SERVICE BULLETIN REVISION NOTICE

ENGINE INDICATING — HARNESS AND JUNCTION BOX ASSEMBLY, EXHAUST GAS TEMPERATURE (EGT) — INTRODUCTION OF

Turbojet Engine Service Bulletin No. V2500-ENG-77-0012 Revision No. 1 dated July 19, 2017.

ENGINE INDICATING — HARNESS AND JUNCTION BOX ASSEMBLY, EXHAUST
GAS TEMPERATURE (EGT) — INTRODUCTION OF

77-21-43
FIGURE 1

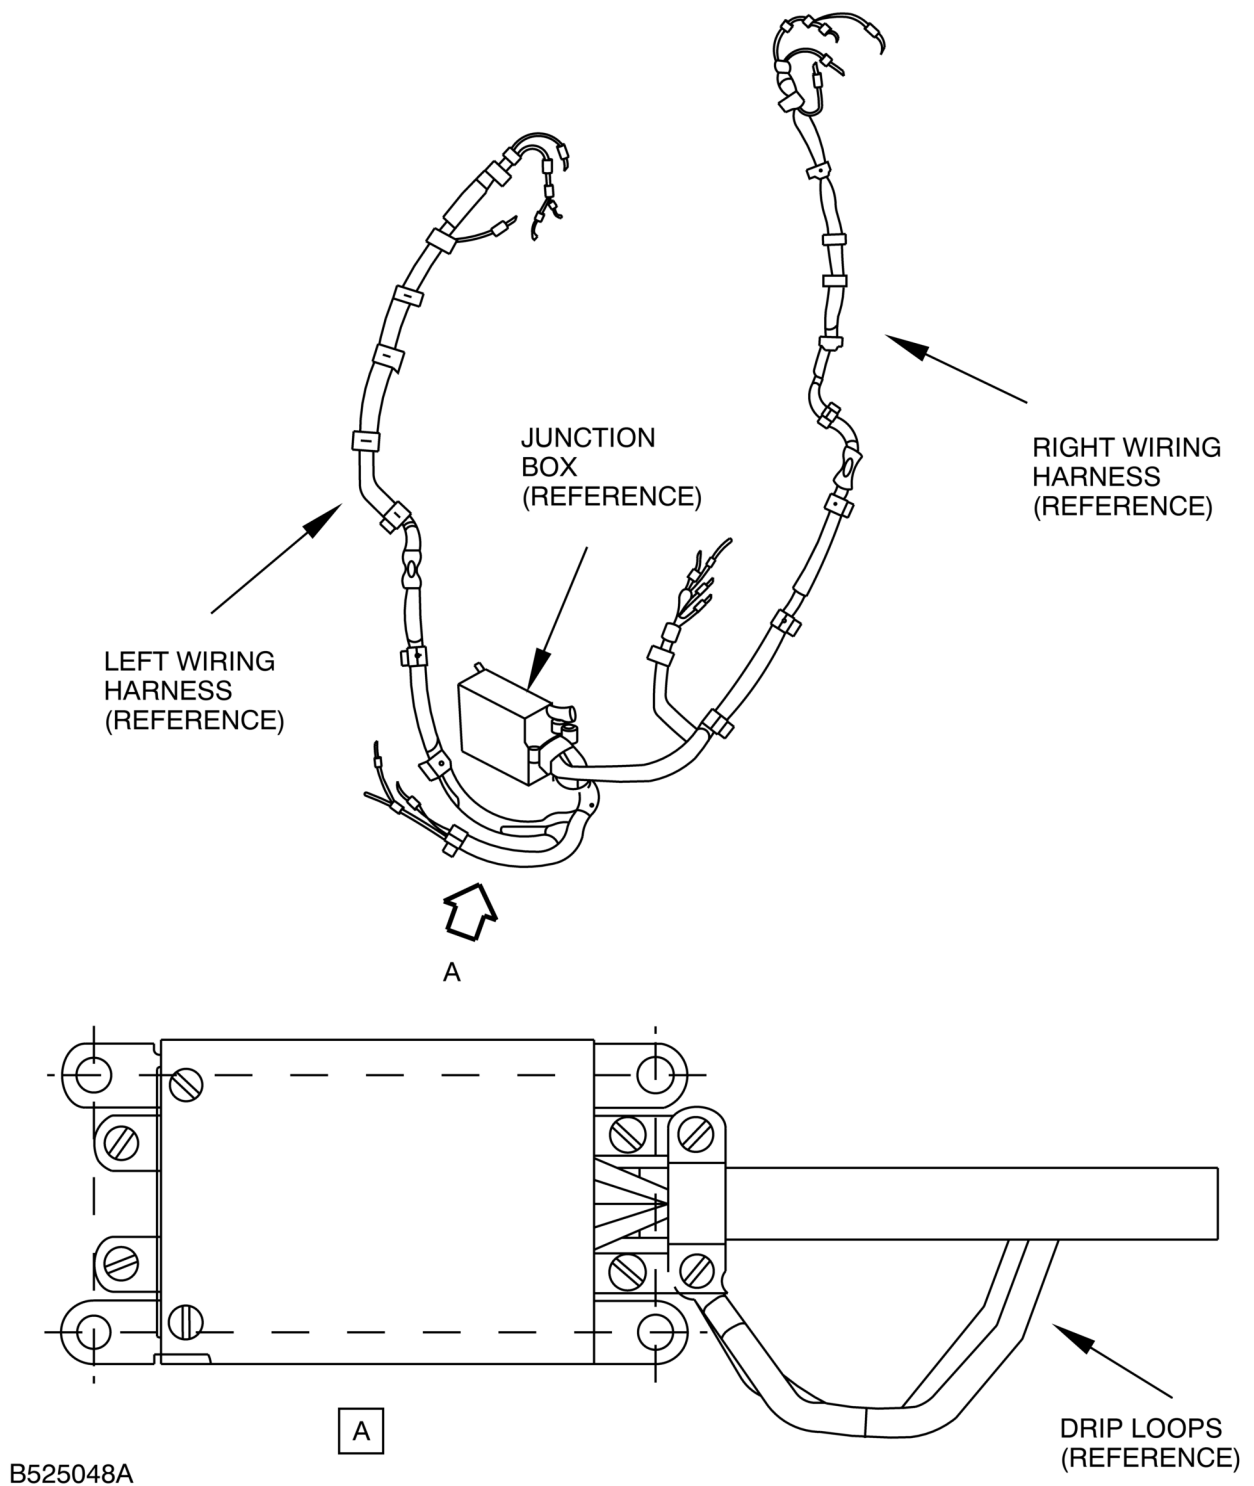
To correct left and right designation within Figure 1.

NOTE: The new EGT Harness has an additional feature called 'drip loops'. See Figure 1.

NOTE: The new EGT Harness has an additional feature called 'drip loops'. See Figure 1.

1 Final torque the larger thread (0.190-32) diameter nut to 25 – 30 lbf-in (2.82 – 3.39 Nm) as specified in Reference 3, SPM, Chapter/Section 70-41-00.

2 Torque the four screws that attach the cover to the junction box to 16 – 22 lbf-in (1.08 – 2.49 Nm) as specified in Reference 3, SPM, Chapter/Section 70-41-00.

EGT HARNESS AND JUNCTION BOX ASSEMBLY
CHART A

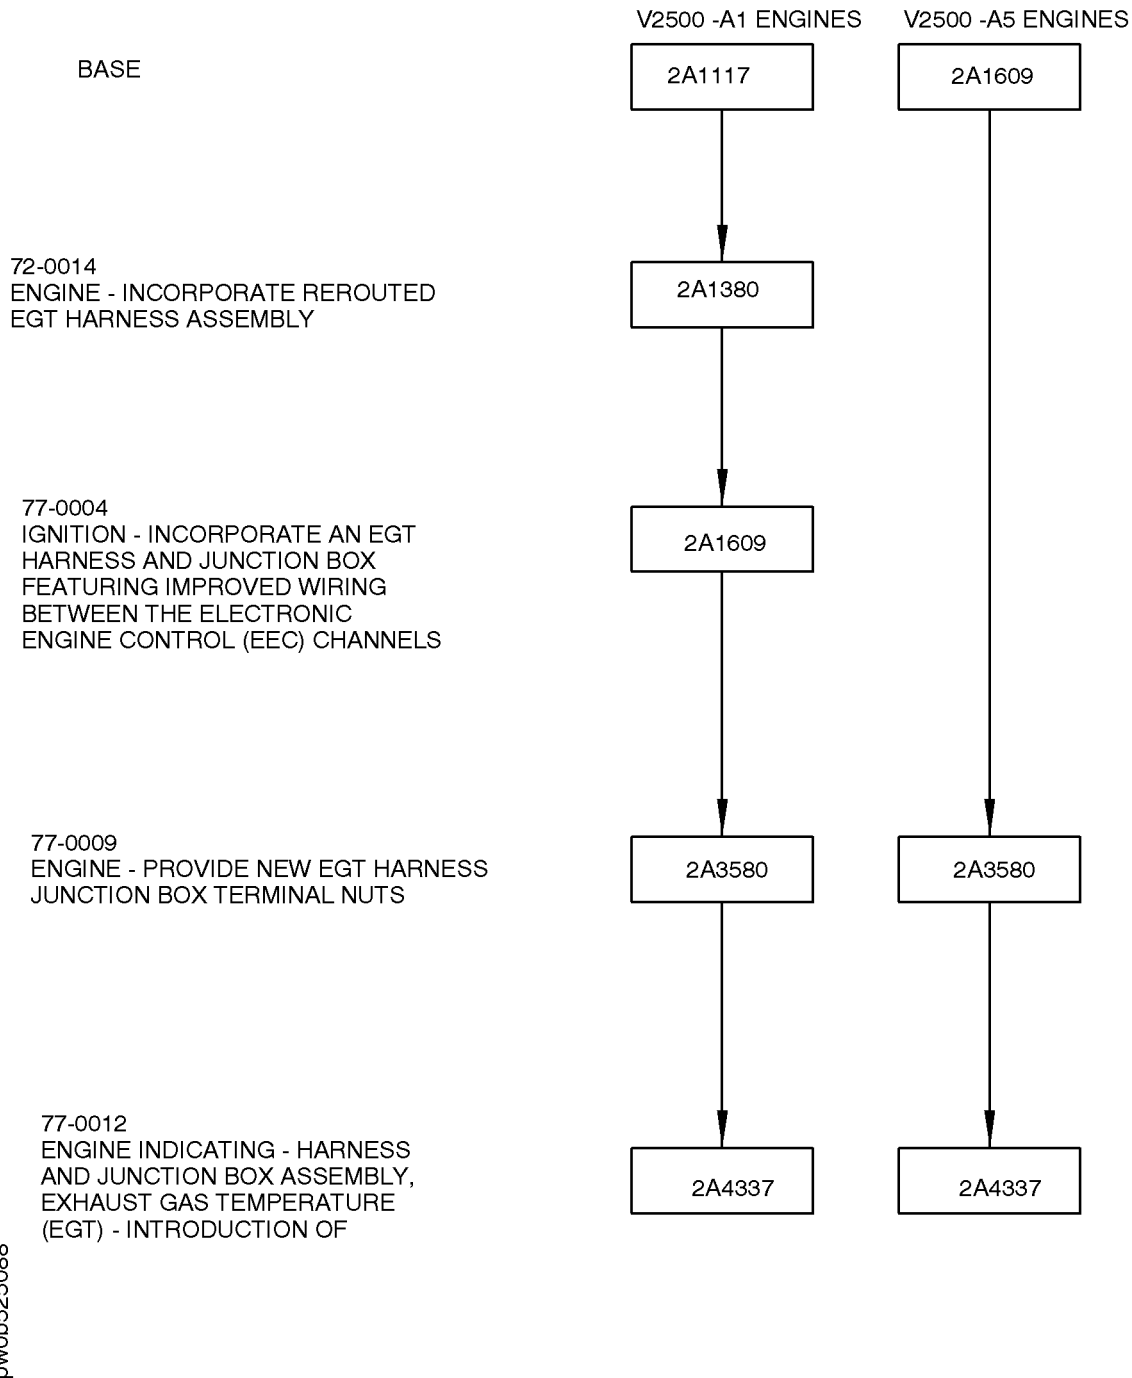
Parts Progression To Show the Changed Part in Relation to Other Parts
